FORM APPROVED
OMB NO. 1004-0137
Expires: January 31, 2018**SUNDRY NOTICES AND REPORTS ON WELLS**
*Do not use this form for proposals to drill or to re-enter an abandoned well. Use form 3160-3 (APD) for such proposals.***SUBMIT IN TRIPLICATE - Other instructions on page 2**

1. Type of Well <input type="checkbox"/> Oil Well <input type="checkbox"/> Gas Well <input checked="" type="checkbox"/> Other: INJECTION		5. Lease Serial No. NMNM110836
2. Name of Operator MESQUITE SWD INCORPORATED Contact: GREG BRYANT E-Mail: greg.bryant@basicenergyservices.com		6. If Indian, Allottee or Tribe Name
3a. Address CARLSBAD, NM 88221	3b. Phone No. (Area code) Ph: 432-563-3355	7. If Unit or CA/Agreement, Name and/or No.
4. Location of Well (Footage, Sec., T., R., M., or Survey Description) Sec 23 T25S R32E NENW 310FSL 1760FWL 32.122300 N Lat, 103.648176 W Lon		8. Well Name and No. PADUCA FEDERAL SWD 3Y
		9. API Well No. 30-025-42258-00-X1
		10. Field and Pool or Exploratory Area SWD UNKNOWN
		11. County or Parish, State LEA COUNTY, NM

Lease Name: Paduca Fed SWD #34

Permanent Abandonment of Federal Wells
Conditions of Approval (LPC Habitat)

Lease Name: Paducah Fed SWD #3Y

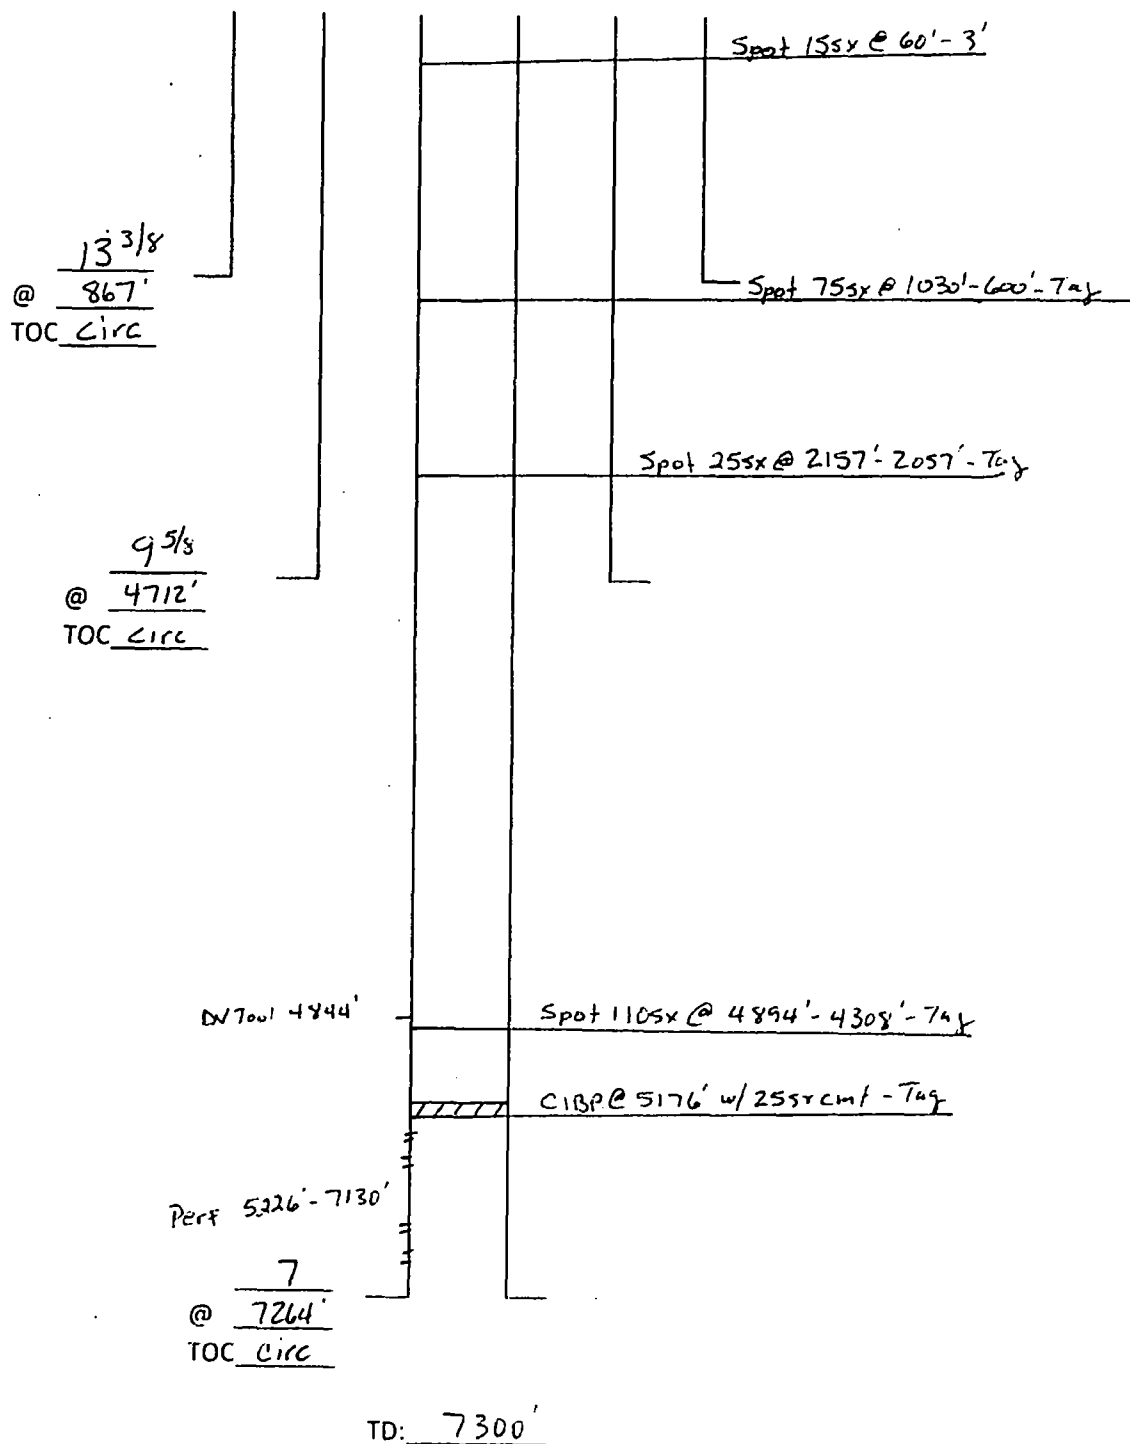
**** BLM REVISED ** BLM REVISED ** BLM REVISED ** BLM REVISED ** BLM REVISED *****X7 NMOC D 9-9-19***FOR RECORD ONLY**

- 1) MIRU. NU WH, ND BOP, POOH w/ Prod Equip
- 2) Set 7" CIBP @ 5176'. Circ hole w/ MLF. Pressure test casing
- 3) Spot 25sx cmt @ 5176' - 5076'. WOC-Tag
- 4) Spot 110sx cmt @ 4894' - 4308'. WOC-Tag
- 5) Spot 25sx cmt @ 2157' - 2057'. WOC-Tag
- 6) Spot 75sx cmt @ 1030' - 600'. WOC-Tag 1080
- 7) Spot 15sx cmt @ 60' - 3'. Verify
- 8) RDMO. Cut off WH & anchors, install DH marker.

**SEE ATTACHED FOR
CONDITIONS OF APPROVAL***Below ground level dry hole marker required*
